STATE OF NORTH CAROLINA
DEPARTMENT OF TRANSPORTATION

SUBJECT: **Permit Modification Request for TIP No. R-2417BB**, Lee County, US 421/NC 87 Bypass from East of SR 1521 to east of NC 42, Federal Aid No. STP-NHF-421(2), State Project No. 8.T540402, NCDOT Division 8, \$475 Debit WBS Element 34431.1.1.

The purpose of this letter is to request modifications to the Clean Water Act (CWA) Section 404 Permit issued by the USACE and the 401 Water Quality Certification issued by the NCDWQ. This modification addresses the revision to the natural stream design of the stream used for stream impacts at Site 6, and provides confirmation of mitigation by the EEP for the associated loss of 190 feet of natural stream design. Revised Plan Sheets 2AI, SAJ, and 2AK, and a new Detail Sheet are attached.

PROJECT REFERENCE NO. R-247BB
 SHEET NO. 2A
 HYDRAULIC ENGINEER
 NORTH CAROLINA PROFESSIONAL ENGINEERS SEAL
 HENRY WELLS
 LICENSE NO. 9334

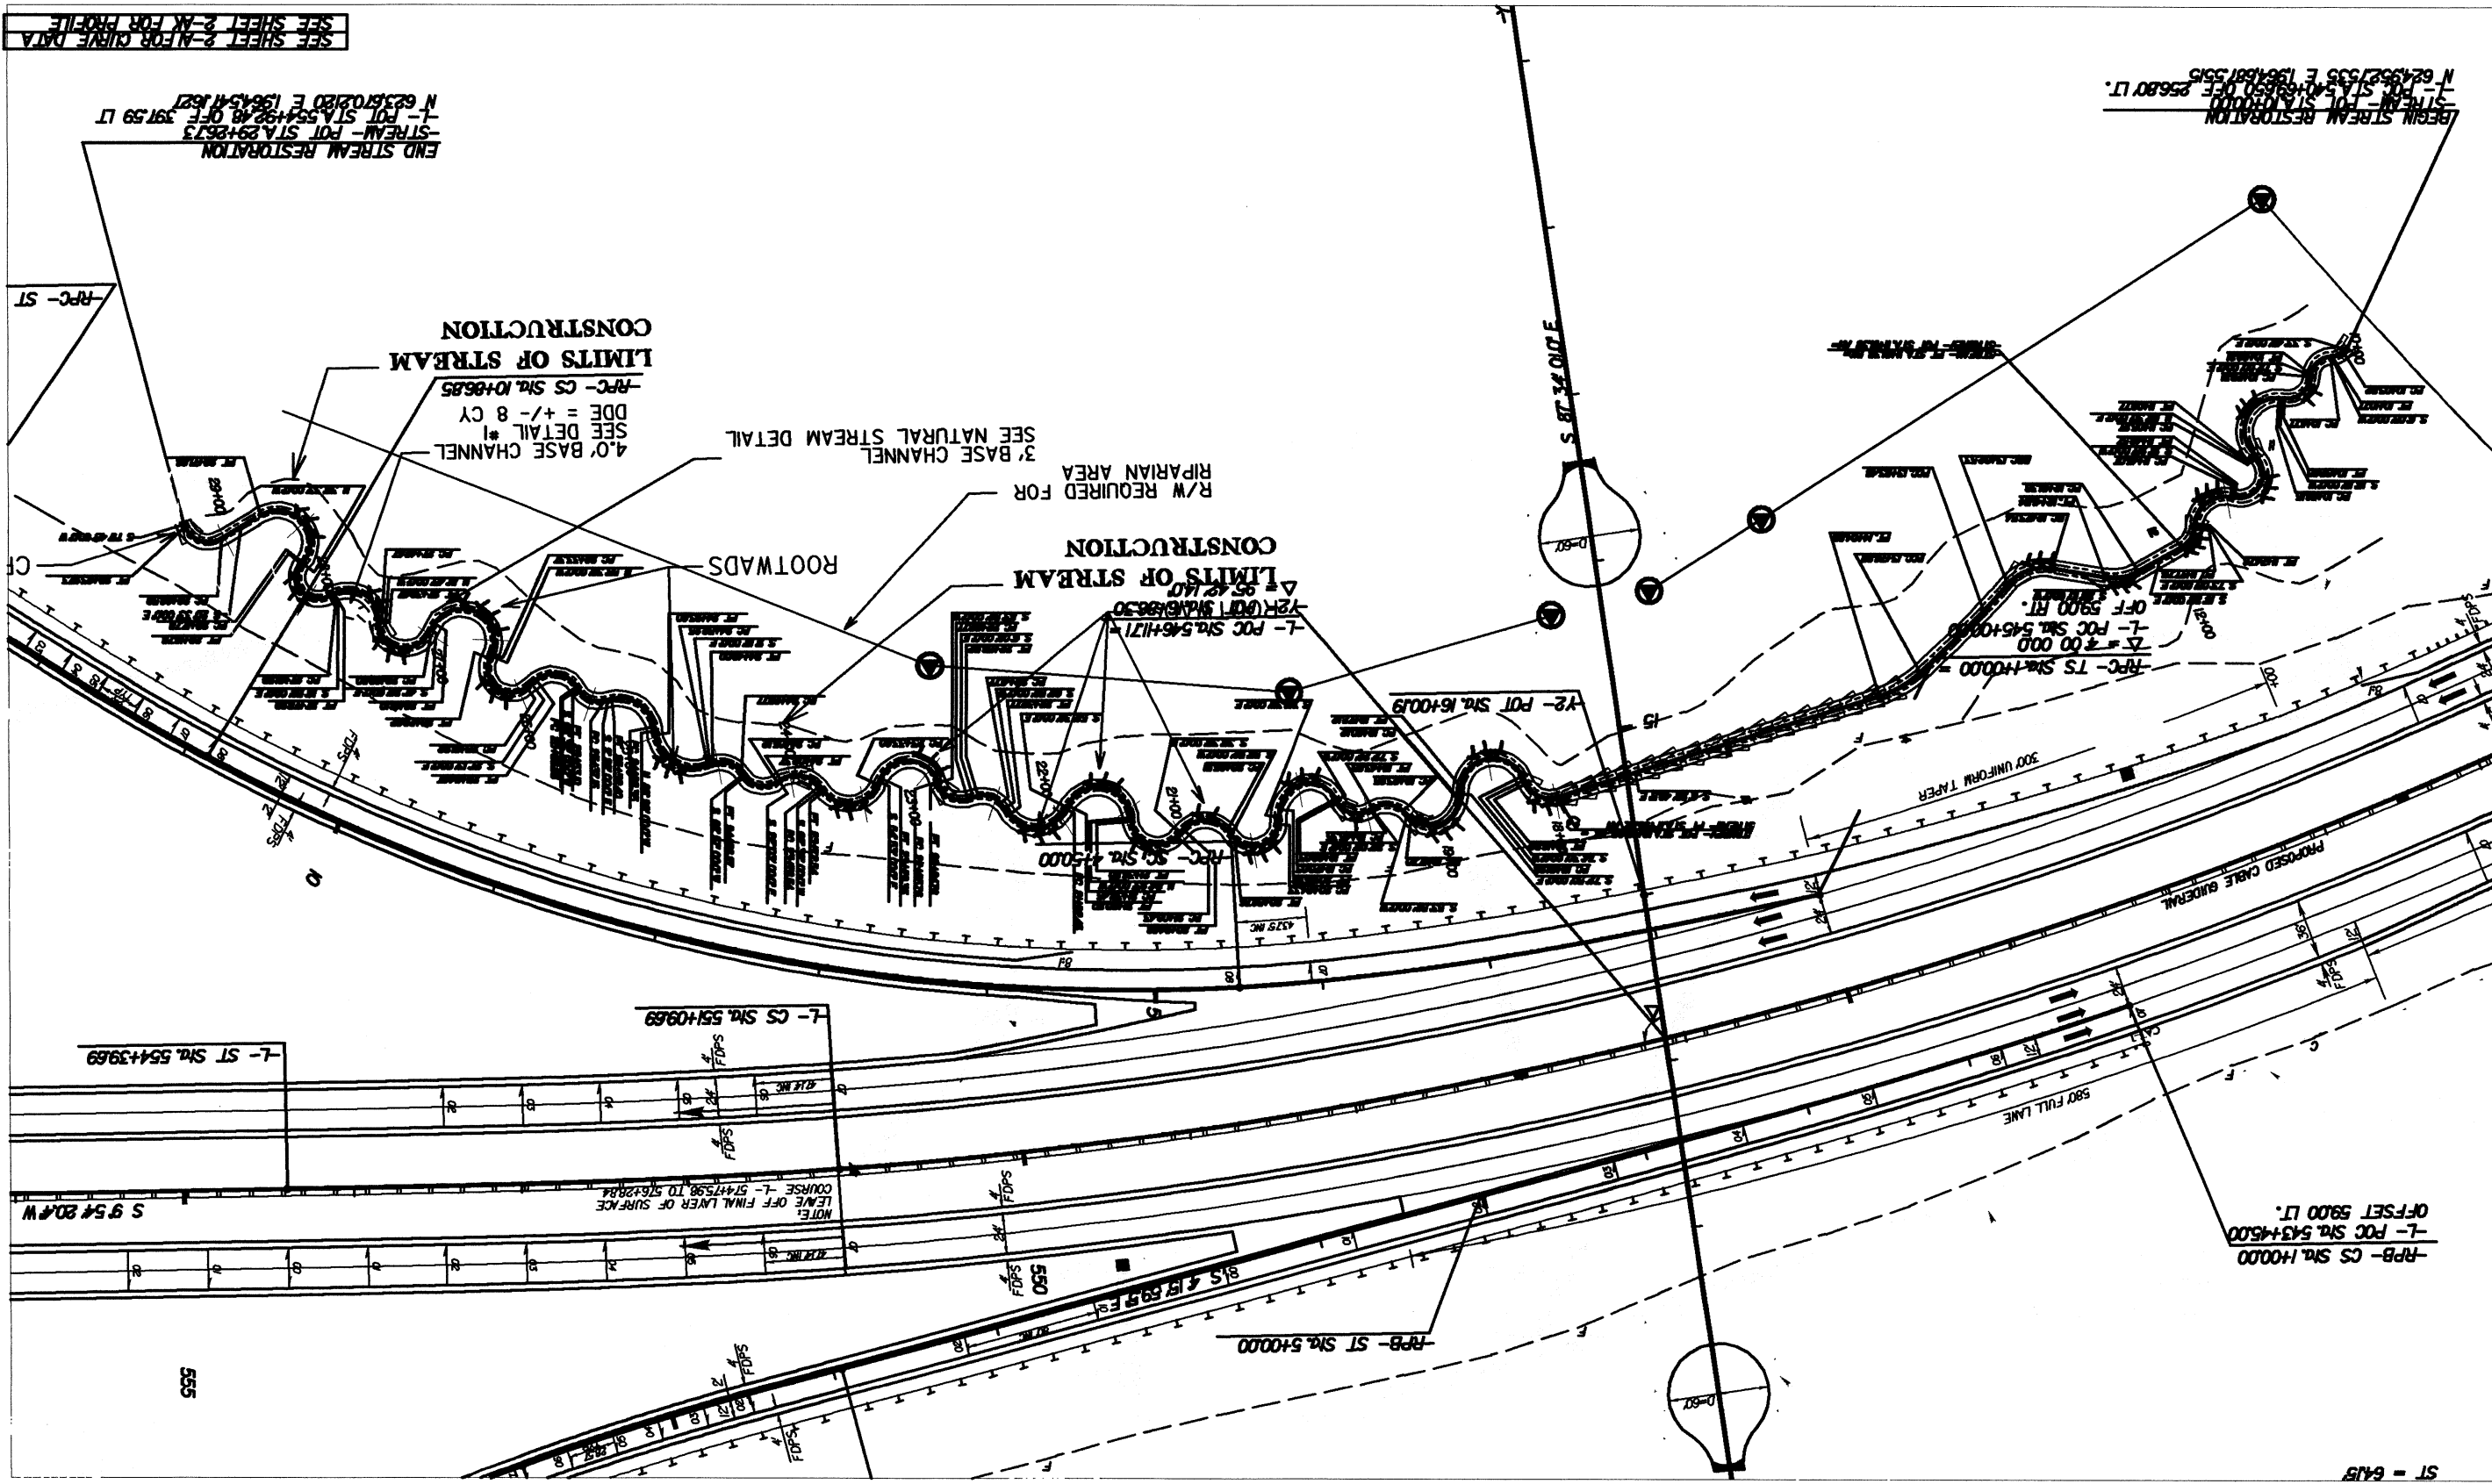
The North Carolina Department of Transportation (NCDOT) proposes a revision to the natural stream design for the stream relocation used for stream impacts at Site 6. A portion of the stream has been redesigned from a Rosgen type "C" channel to a Rosgen type "B" channel. The need for this redesign is due to this section of stream being located

along a drained pond bottom that is on a 7% slope. The "B" type channel design being incorporated in this modification utilizes more gradient control structures and less sinuosity than the originally permitted "C" type design. This redesign has resulted in a 190-foot loss of natural stream design, reducing the permitted 1,924 feet of natural stream design to 1,734 feet. In support of this permit modification request, the NCDOT has received confirmation from the North Carolina Ecosystem Enhancement Program (EEP) that they will be providing compensatory mitigation for the associated 190-foot loss of natural stream design (letter attached).
